ADDENDUM NO. 1

TO THE INVITATION TO BID DOCUMENTS FOR Barnett Pump Station

May 6, 2025

SCHEDULES & DETAILS - PLUMBING

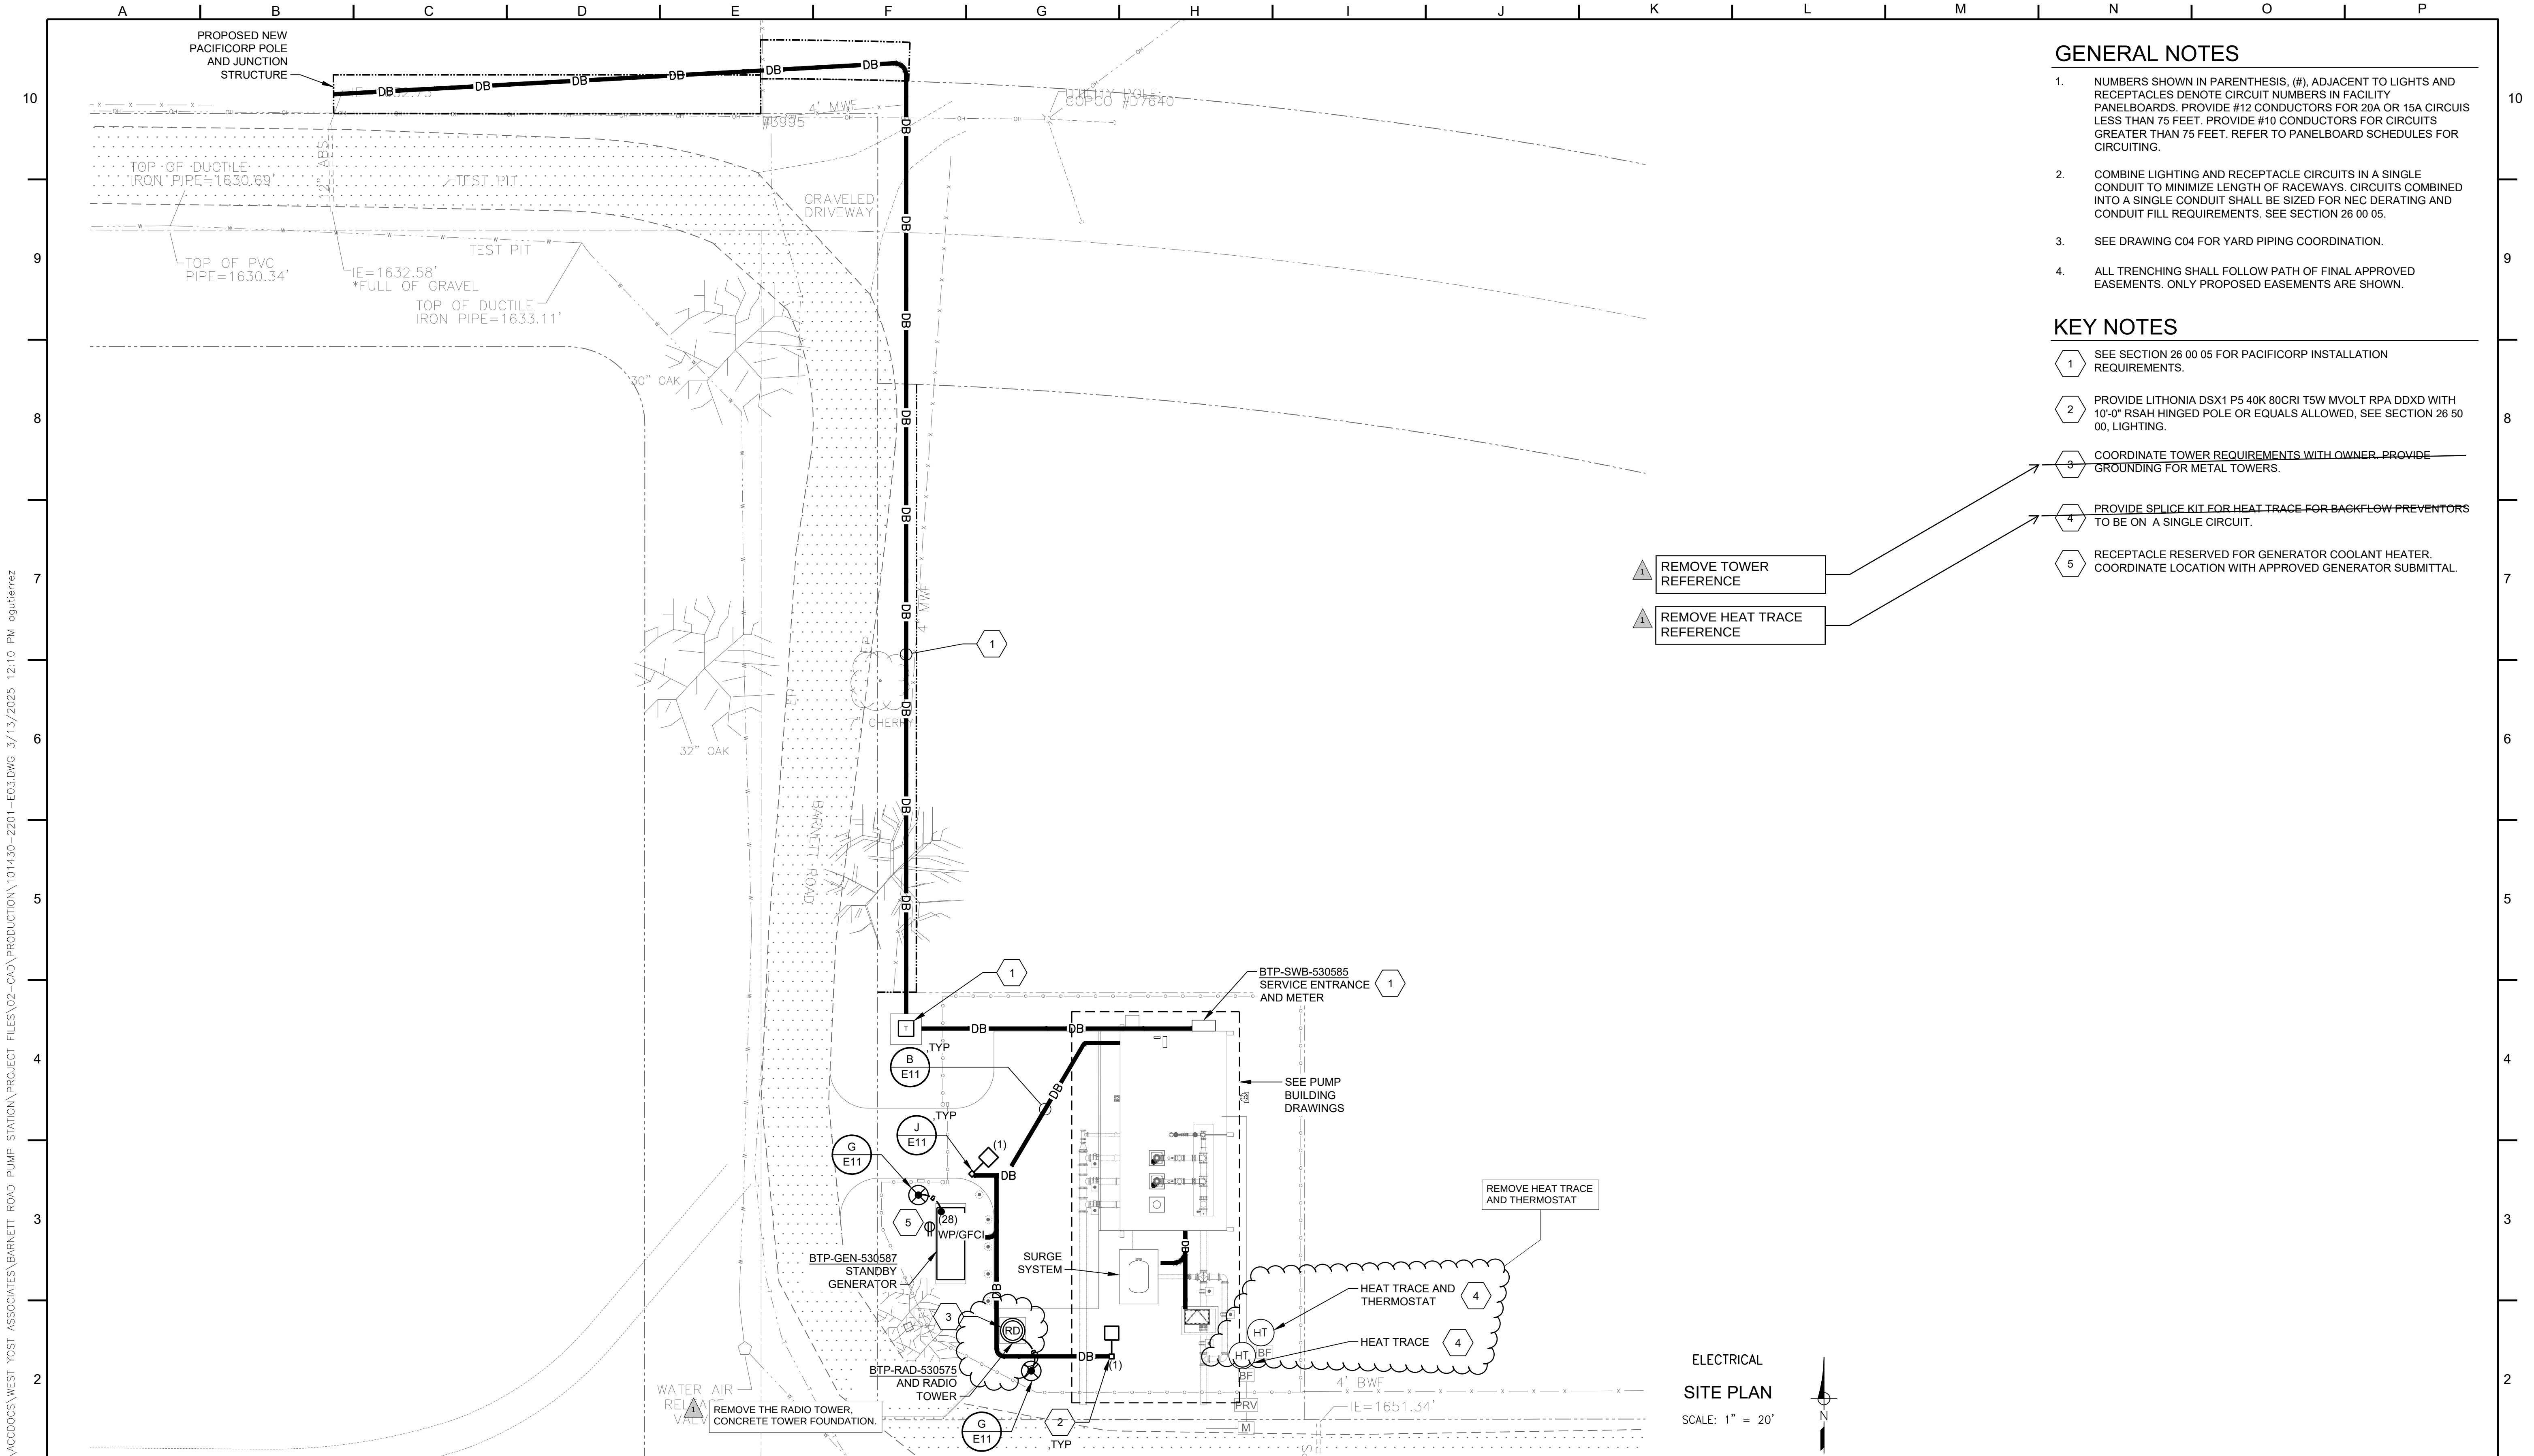
REMOVE HEAT TRACE FROM BID DOCUMENTS.

ELECTRICAL SITE PLAN

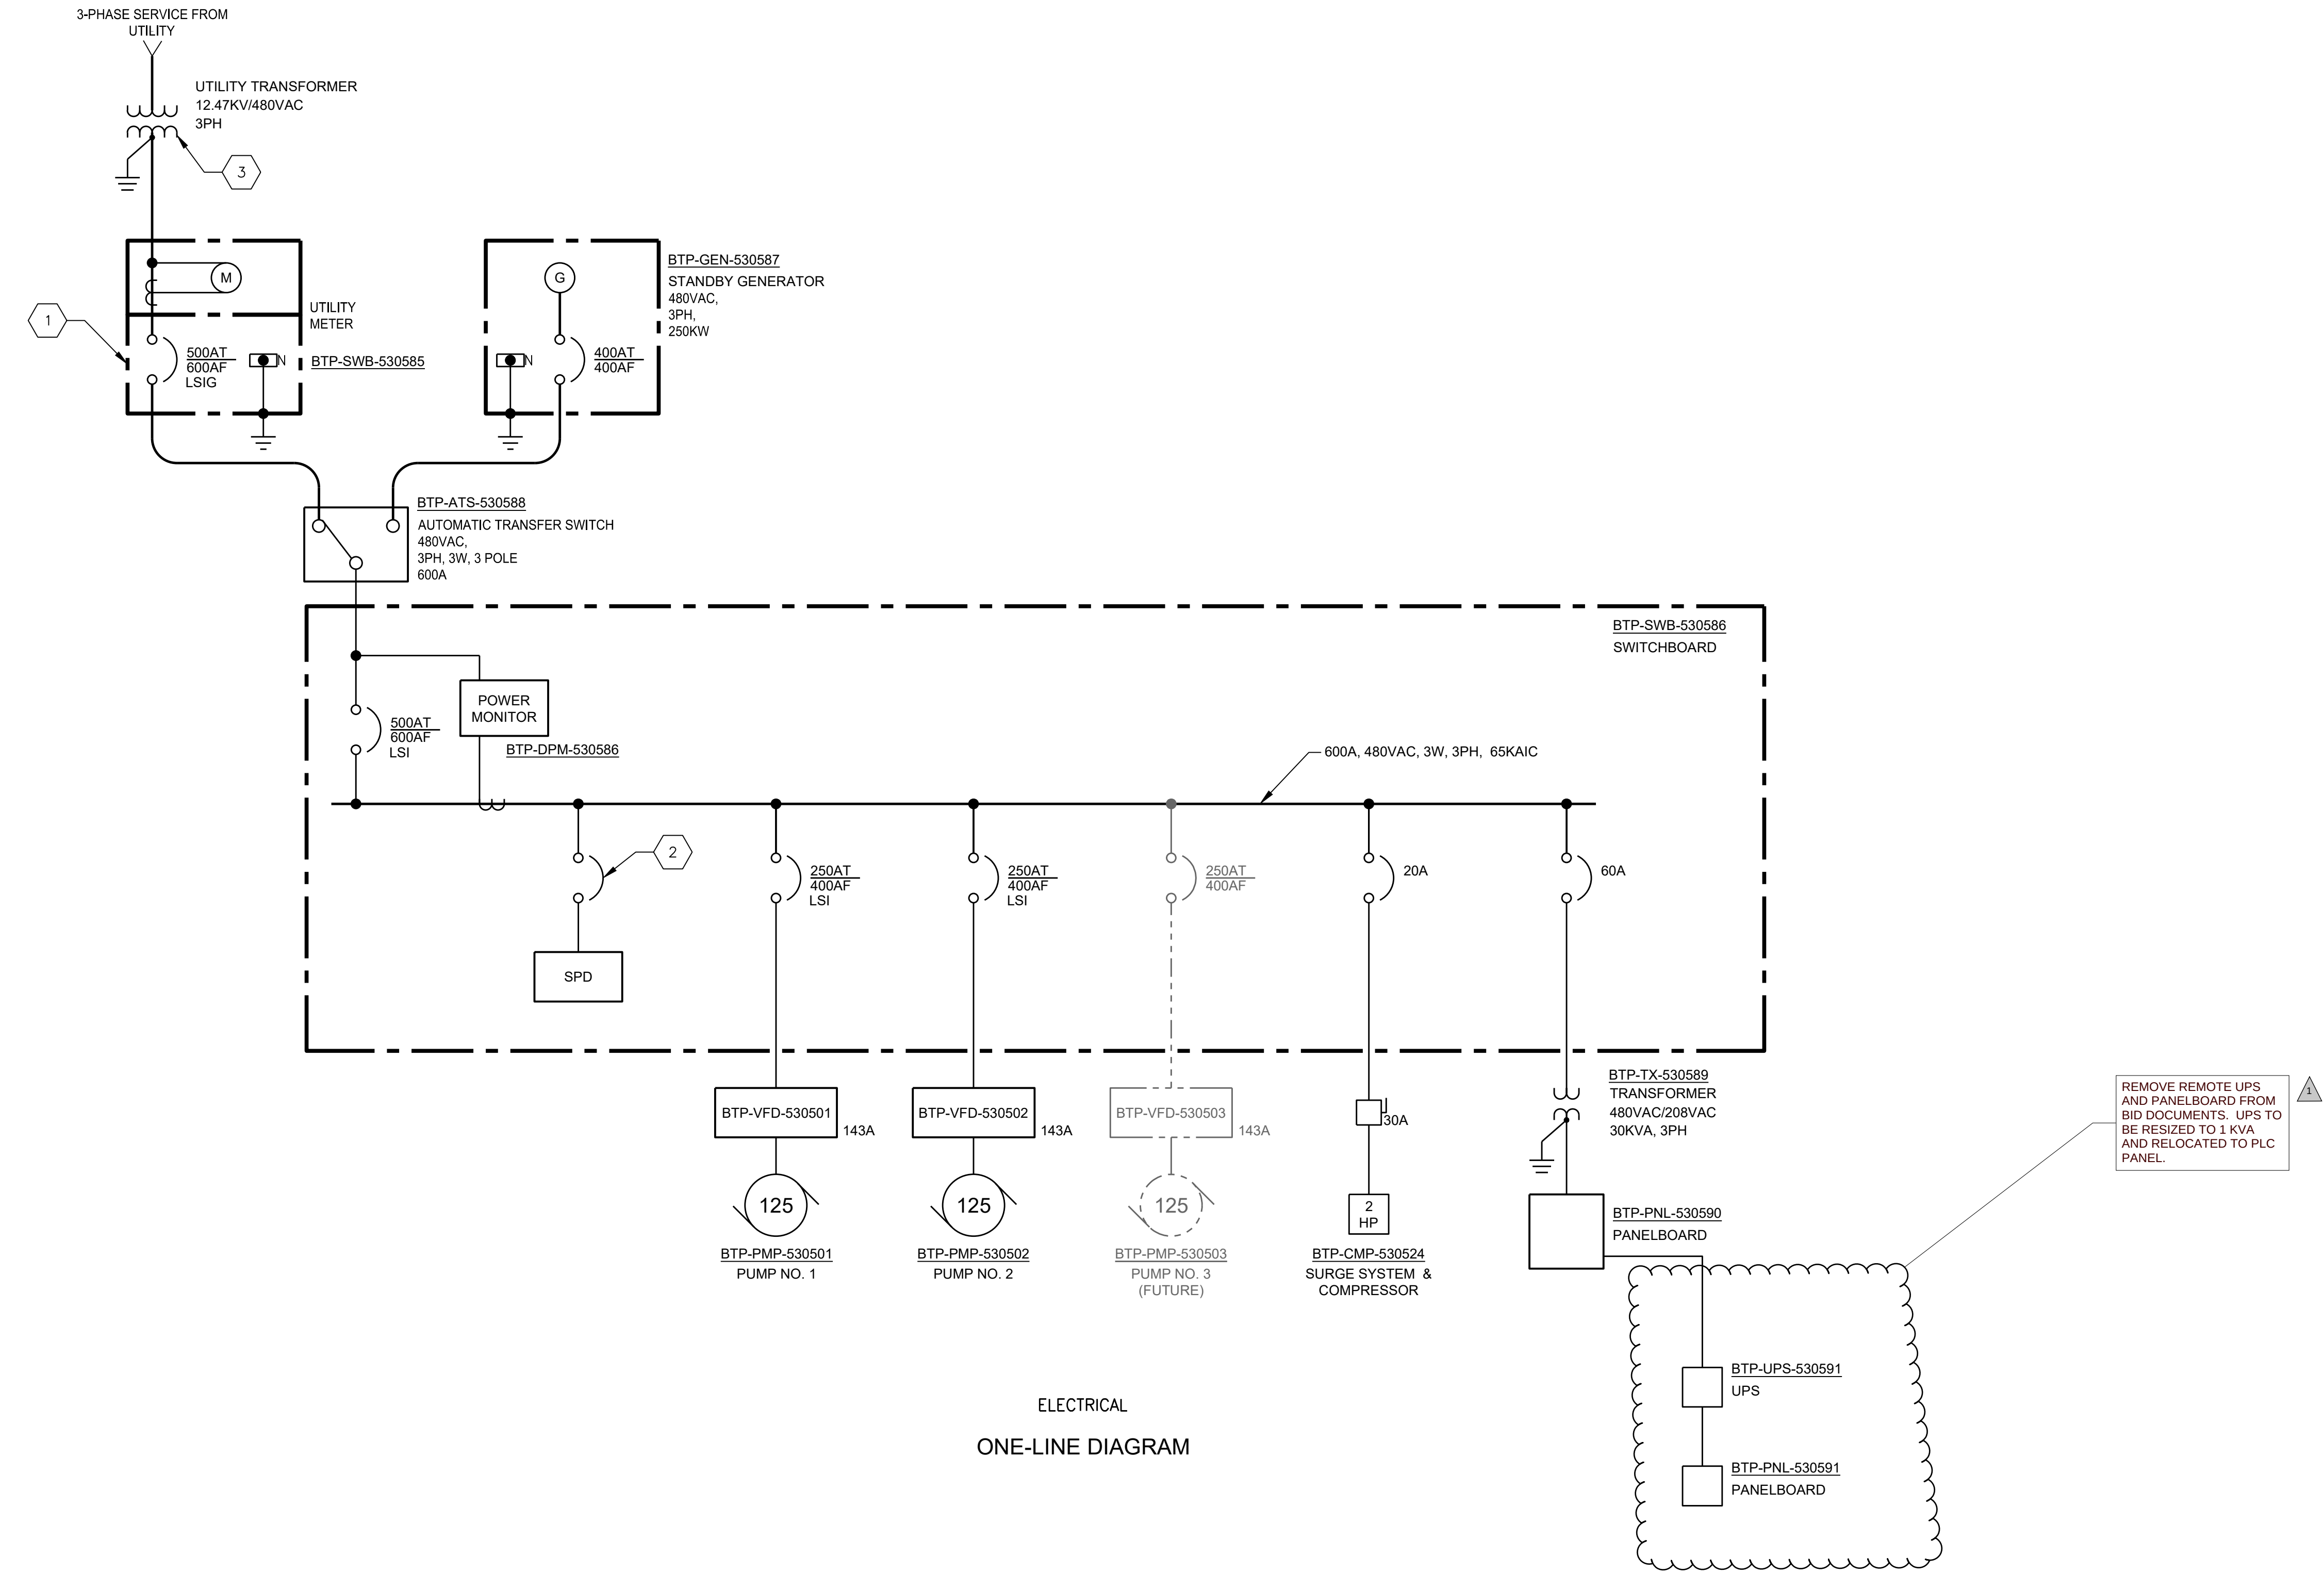
REMOVE TOWER REFERENCE

REMOVE HEAT TRACE REFERENCE

ELECTRICAL ONE LINE DIAGRAM

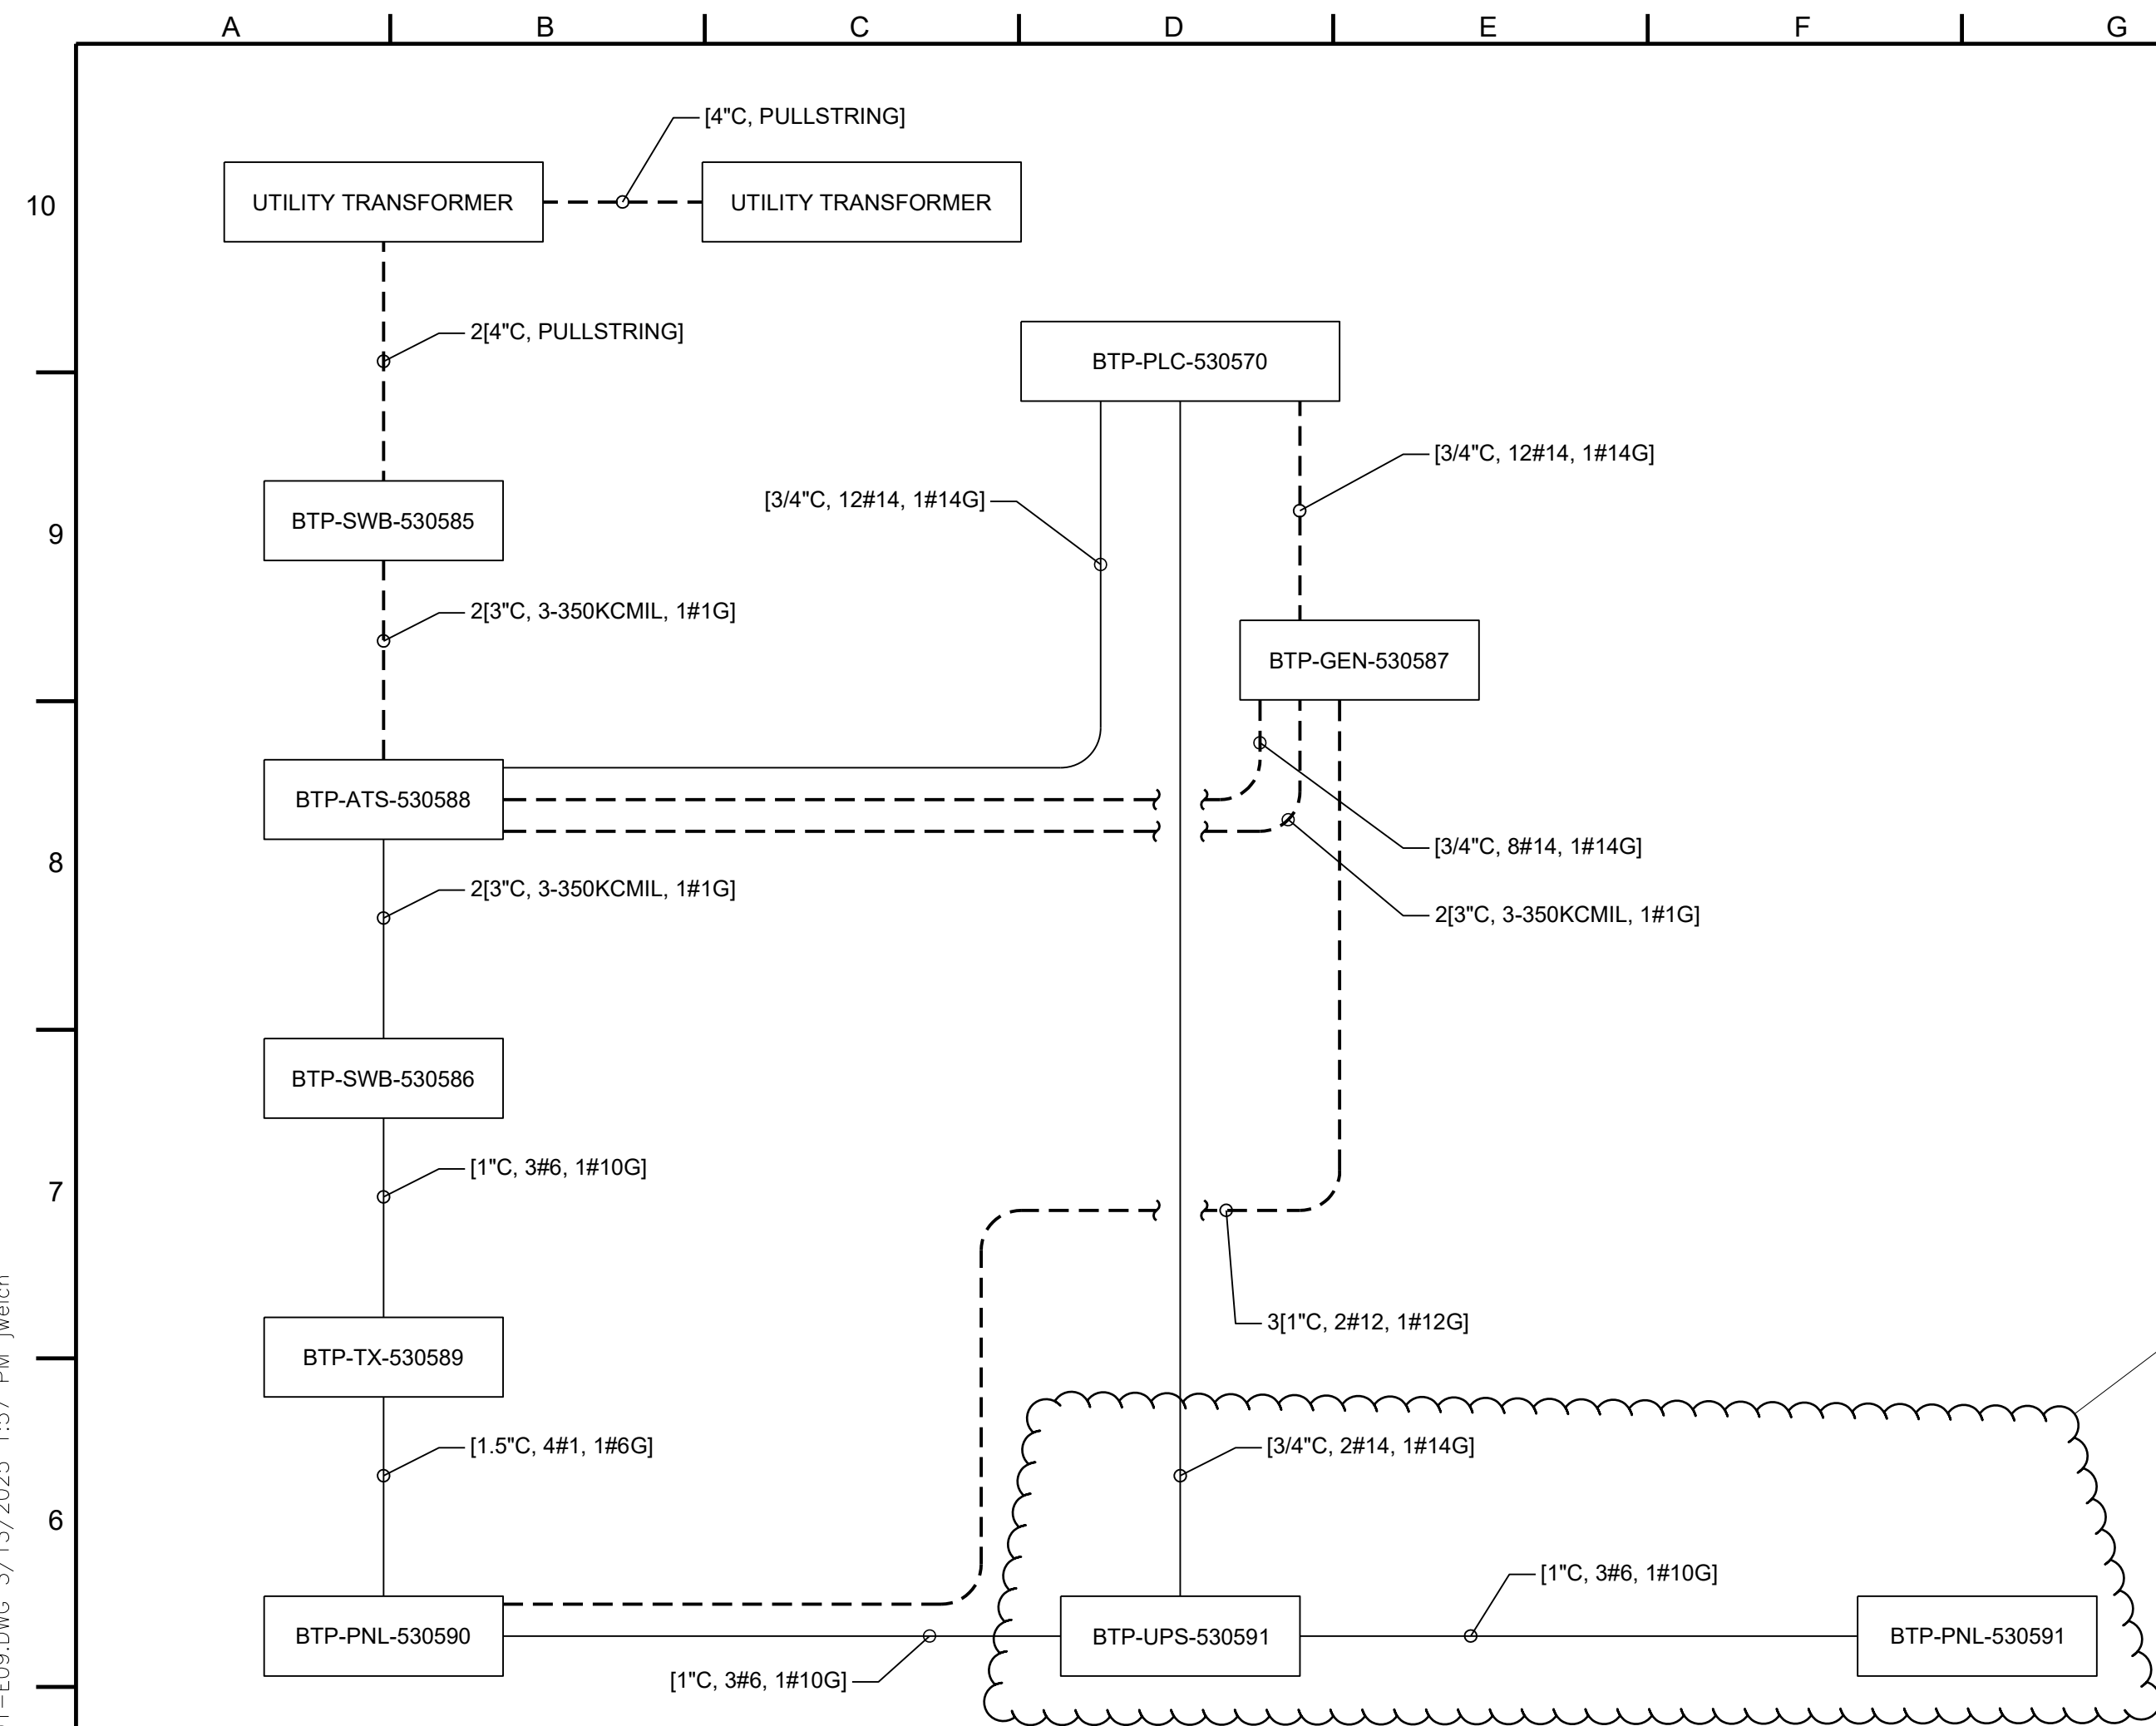
REMOVE 10KVA REMOTE UPS AND PANELBOARD FROM BID DOCUMENTS. RESIZED 1 KVA UPS AND BATTERIES RELOCATED TO PLC PANEL. BTP-NIP-530575 TO BE SUBFERD FROM PLC.

REMOVE HEAT TRACE FROM BID SET

REMOVE BTP-PNL-530591 FROM THE BID SET.

REVISED PHASE B TOTAL LOAD.
